**Site Formation and Infrastructure Works
for Public Housing Development near Tan Kwai Tsuen,
Yuen Long – Investigation, Design and Construction**

**FINAL AIR VENTILATION
ASSESSMENT REPORT -
EXPERT EVALUATION**

199086/BIN/104/Issue 3
July 2023

Appendix 1	Cross Sections of Proposed Scheme
Appendix 2	Response to Comments Records

Drawing title
ILLUSTRATION OF WIND FLOW FROM SOUTH AND SOUTH SOUTHEAST WIND DIRECTIONS

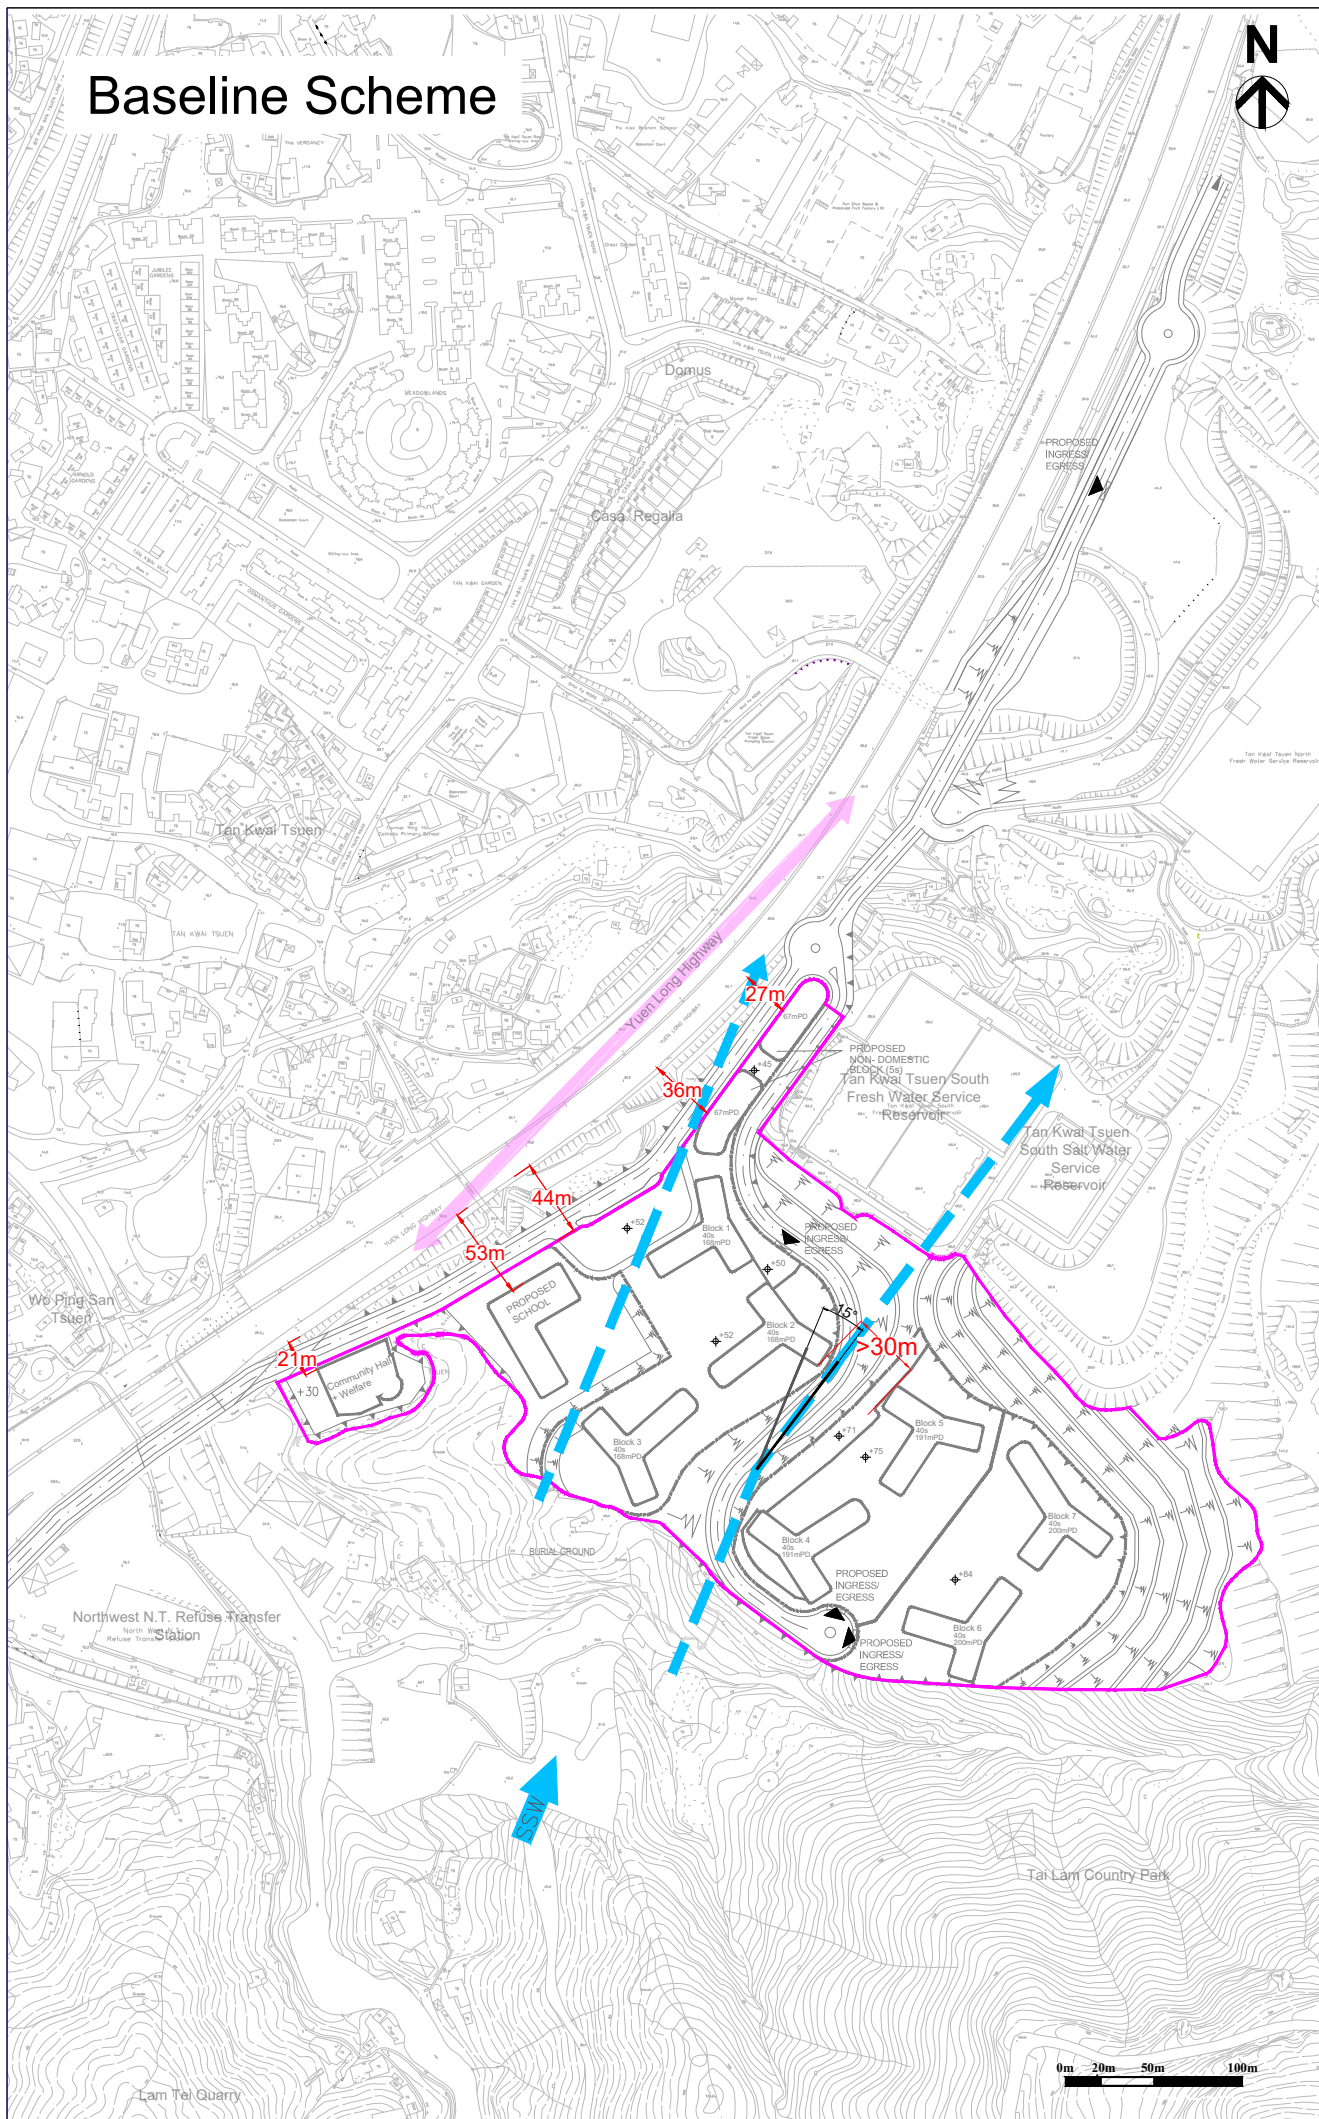
<p>28) Para. 3.3.3 S & SSE Winds – It is unclear on how “the S and SSE winds would replenish along Yuen Long Highway and settle further downstream at Tan Kwai Tsuen and Wo Ping San Tsuen” as stated by the Consultant. Please justify and indicate the distance between the proposed</p>	<p>Noted. The distance between the proposed development and its nearest downstream area (i.e. Tan Kwai Tsuen) has been indicated in Paras. 3.2.9, 3.3.3 and 3.4.3. Figures 3.2 and 3.3 are revised accordingly.</p>

Drawing No. Figure 3.4

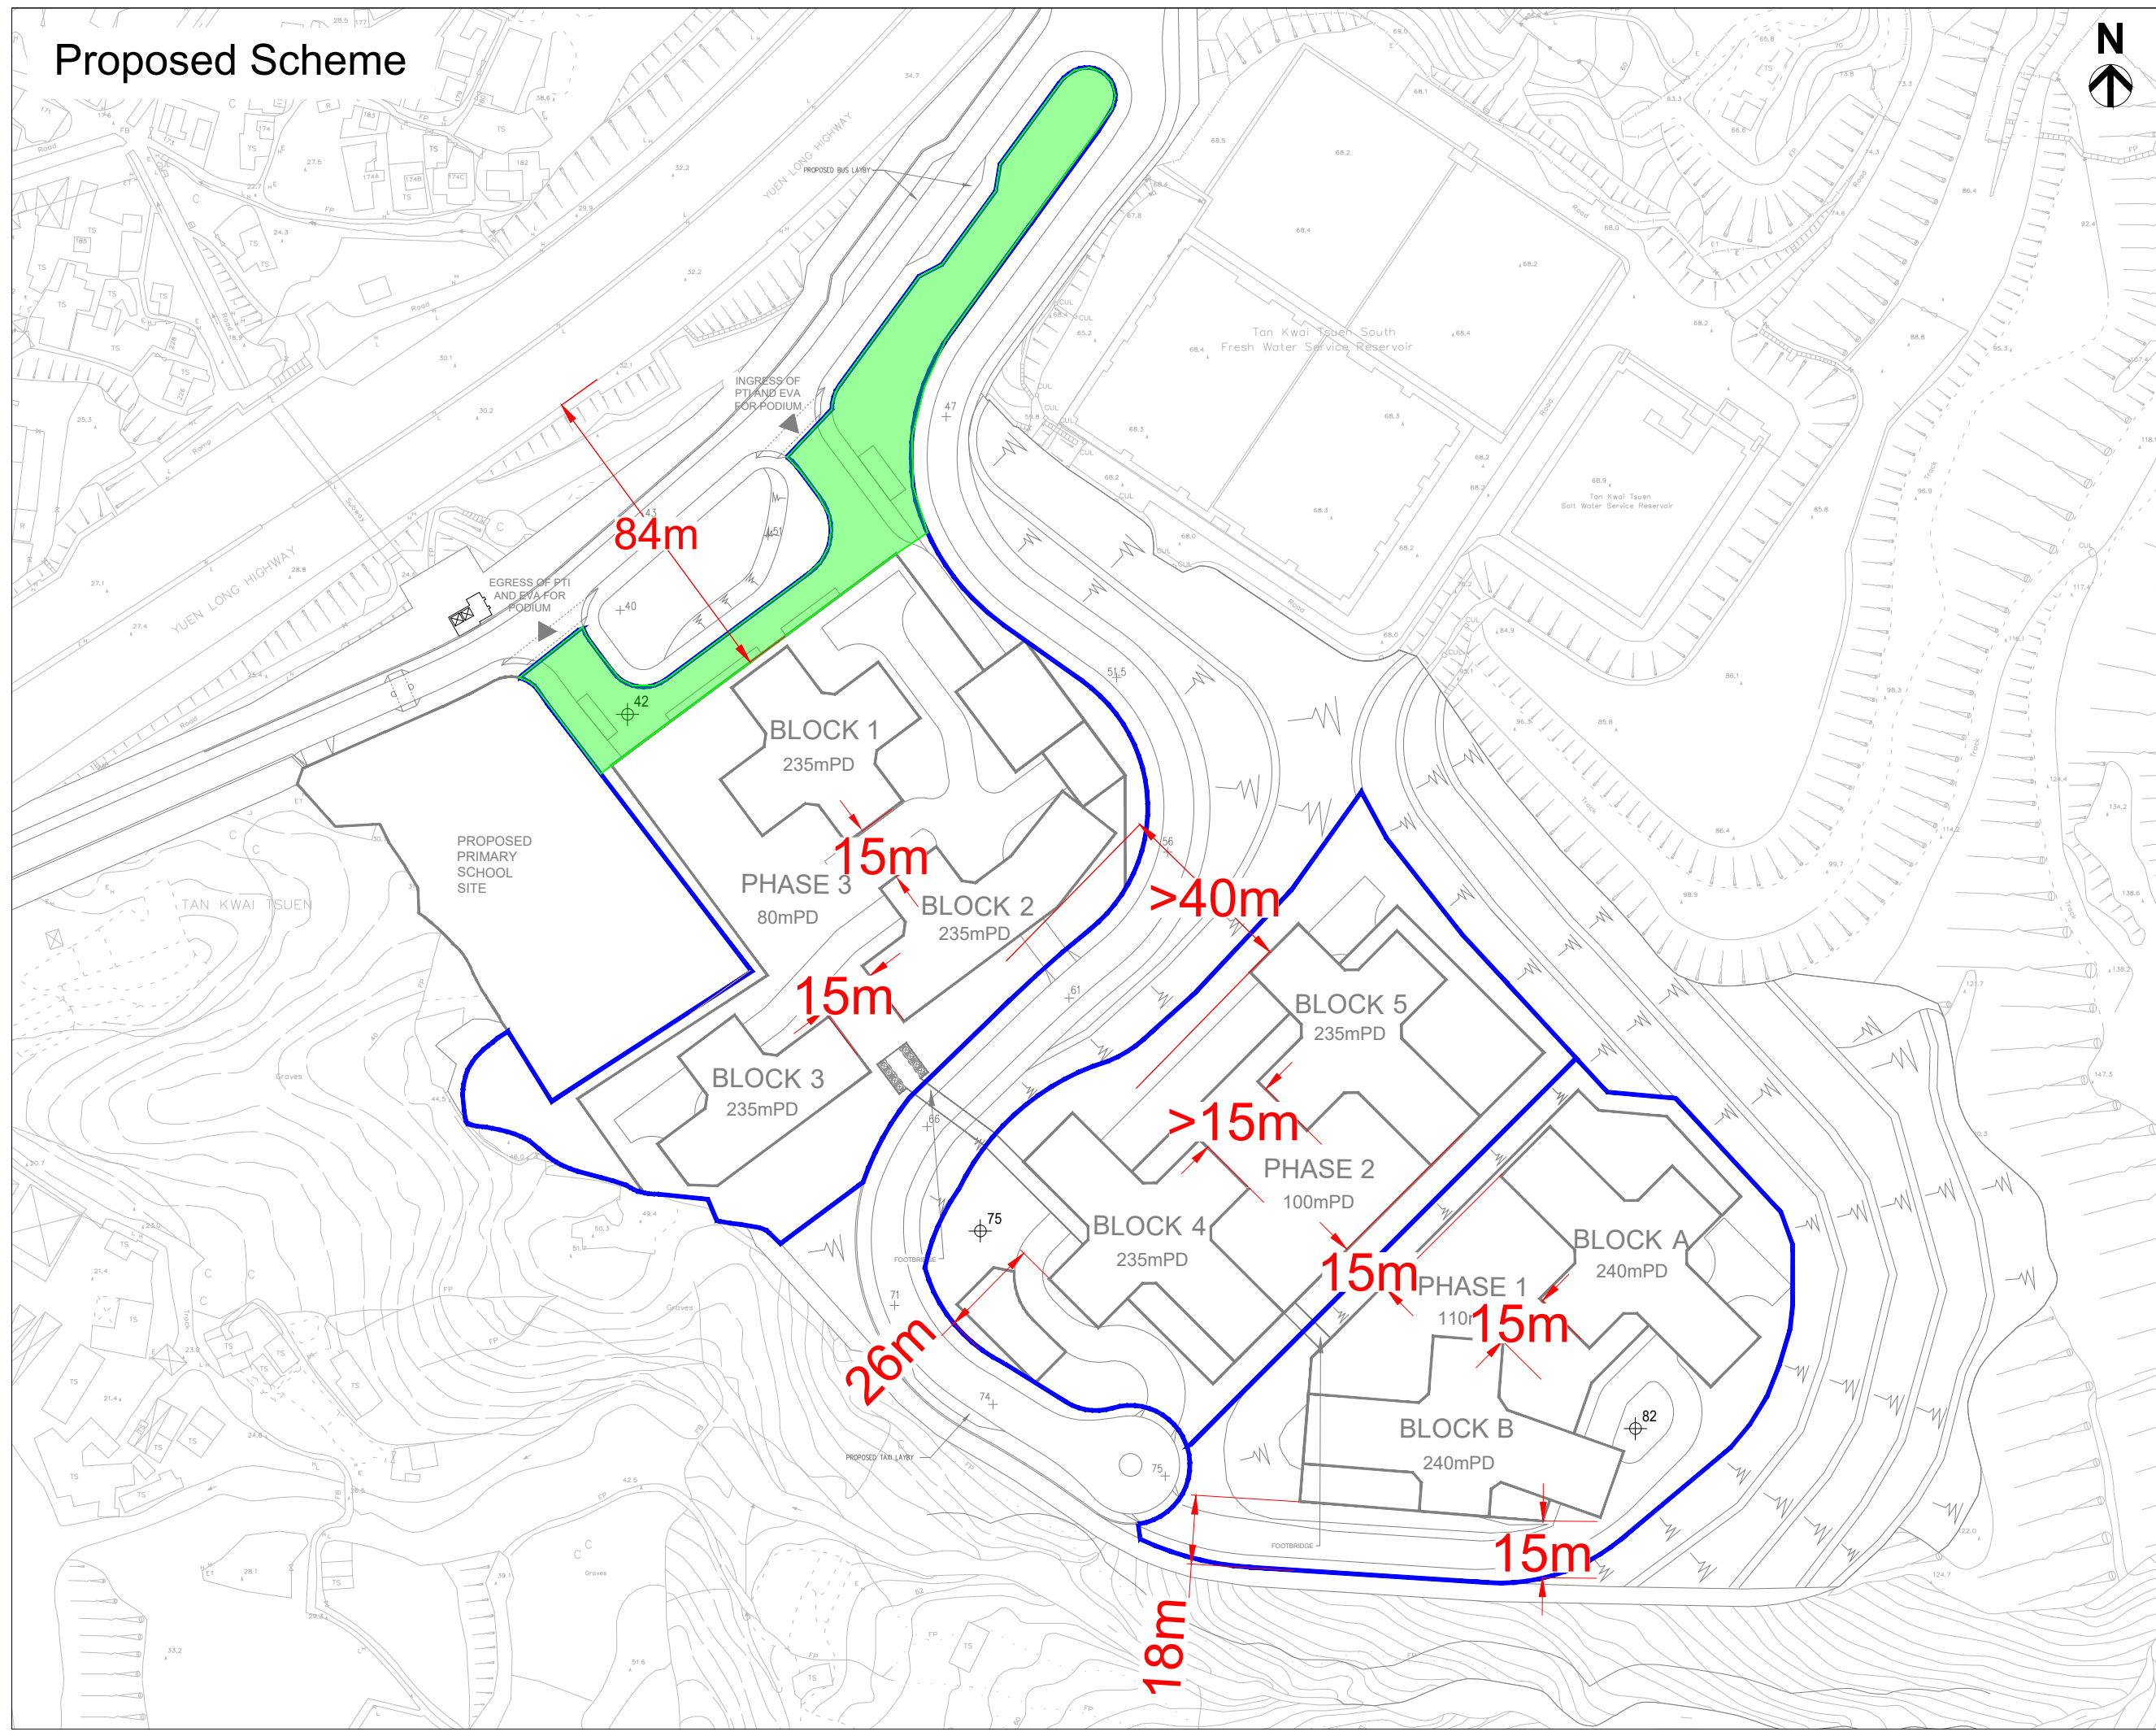
Comments	Responses
development and its downstream areas on plan(s) (e.g. Figure 3.3).	
<p>Paras. 3.3.5 to 3.3.10 & Figure 3.4 SSW Wind – The illustration of wind flow (in blue arrows) in Figure 3.4 does not align with the SSW wind direction and involves change in direction from the original air path more than 15 degrees. Please review and rectify Figure 3.4 and Paras. 3.3.5 to 3.3.10, as appropriate</p>	<p>Noted. Paras. 3.3.8 and Figure 3.4 have been amended.</p>
<p>29) Para. 3.5.1 Building Design Features and Figure 3.5 Proposed Mitigation Measures of Proposed Scheme –</p> <p>a) Please include the over 40m-wide building separation between Blocks 2 and 5 (i.e. the proposed access road between the lower and middle platforms), as indicated in Para. 3.2.4 & Figure 3.1, in this paragraph and clearly indicate it in Figure 3.5.</p> <p>b) According to the Explanatory Statement of the OZP, design measures including non-building area would alleviate the potential air ventilation impacts of the proposed development and with reference to the relevant discussion in Section 3, please indicate the location of the open area/space along the western boundary of the Site in Figures 3.1, 3.2, 3.4 and 3.5, and add it as one of the building design features in this paragraph.</p>	<p>a) Noted. Paras. 3.2.4 and Figure 3.1 have been amended to indicate the over 40m-wide building separation between Blocks 2 and 5.</p> <p>b) Noted. Para. 3.5.1 and Figures 3.1, 3.2, 3.4 and 3.5 have been amended to indicate the open area along the western boundary of the Site as one of the building design features.</p>
